Groundwater Application Review Summary Form

Application # G- 18300

TO: Water Rights Section Date 10/26/2023
 FROM: Groundwater Section Joe Kemper
Reviewer's Name
 SUBJECT: Application G- 18300 Supersedes review of 8/25/2016
Date of Review(s)

A. GENERAL INFORMATION: Applicant's Name: Legacy Ranches LLC County: Crook

Water-Level Trends in Nearby Wells

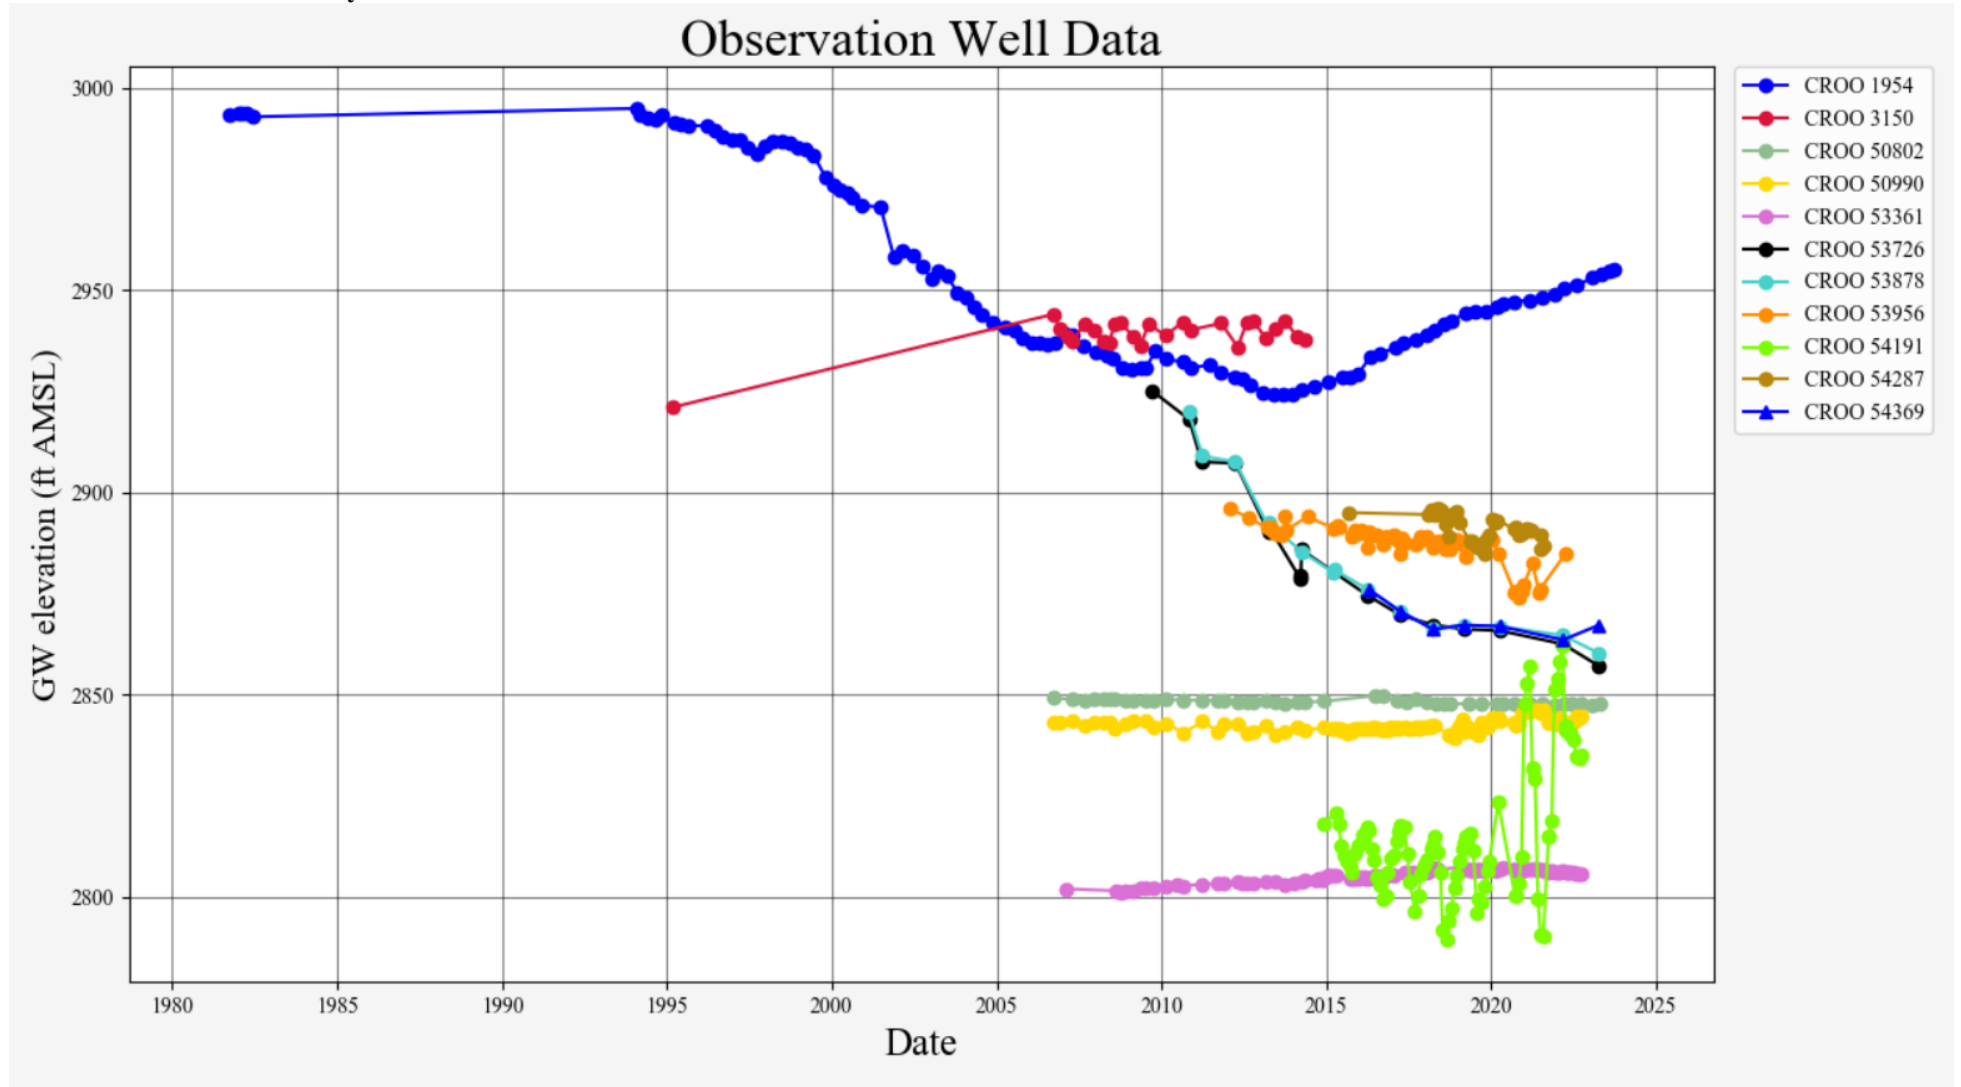
B3. **Groundwater availability remarks:** The applicant’s wells access groundwater hosted in lavas and sediment of the eastern extent of the Deschutes Formation, specifically the plateau SW of the city of Prineville. Since the original groundwater review for this application was completed, the City of Prineville commissioned their pilot ASR project just east of the applicant’s wells, which involved extensive groundwater level data collection. A review of these data indicate that water levels in the vicinity have shown 1) positive response to the ASR recharge 2) relatively stable trends despite increased groundwater pumpage in the area and 3) localized wells with declining trends. Two wells on the airport plateau (CROO 53726 and CROO 53878) have shown more than 50 feet of declines since monitoring began. However, multiple lines of evidence suggest these two wells are completed within an intracanyon lava flow that is bounded by mostly low permeability material (Groundwater review for App G-17338) (see hydrograph below). The high magnitude decline appears to be confined to CROO 53726 and CROO 53878, but CROO 54287 and CROO 53956 may show a lower magnitude, diffused response to those local declines.

The hydrogeologic data in the area indicate that there are sharp permeability boundaries that are likely to exacerbate interference and water supply problems. There is also concern that the requested rates are higher than expected yields in the applicant’s wells. Considering water level trends and available water budget estimates for the area, there is not a preponderance of evidence that the target aquifer is over-appropriated. The above permit conditions are recommended to address potential interference or decline issues. See the table in page 1 for reference level information.
